Vermont Agency of Transportation
RECEIVED
 CK'D BY GML CK'D BY JEL
 11:20 am, Mar 19, 2012
 RESUBMIT APPROVED X
 BY KMH DATE 3/19/2012

PROJECT: 1111111111

DESCRIPTION: T-BUCK CONSTRUCTION

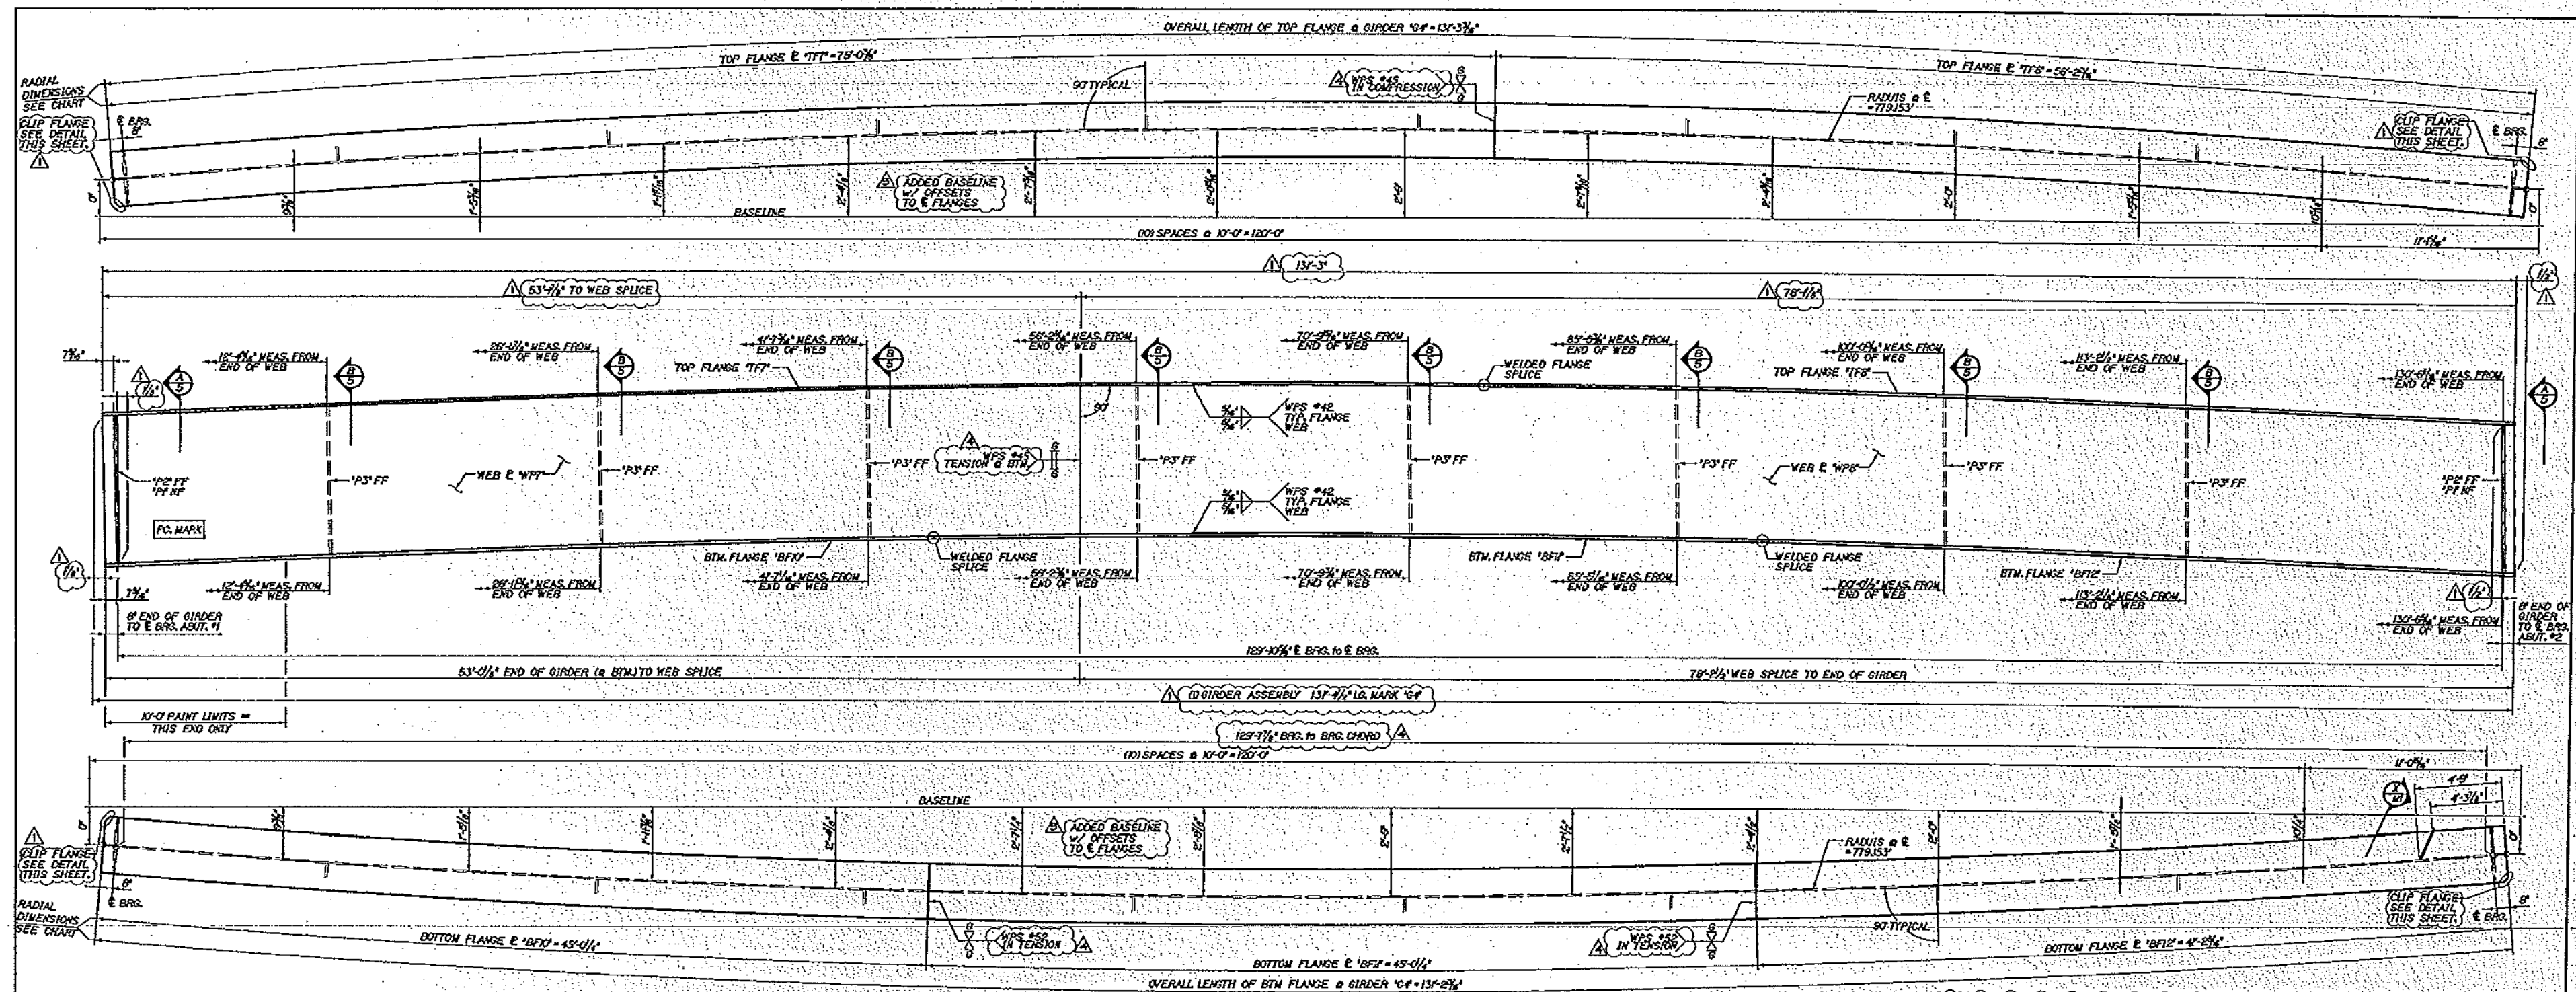
STIFFENERS AND ENDS OF BEAM CHANGED TO BE VERTICAL AT STEEL DEAD LOAD CONDITION. HANGING DIMENSIONS ADDED TO THE BOTTOM OF THE STIFFENERS. DIMENSIONS SHOWN ARE TO THE CENTER OF THE BEAM. IN THE CASE OF THE TOP FLANGE, DIMENSIONS ARE TO THE CENTER OF THE FLANGE. DIMENSIONS HAVE BEEN RECHECKED ACCORDINGLY.
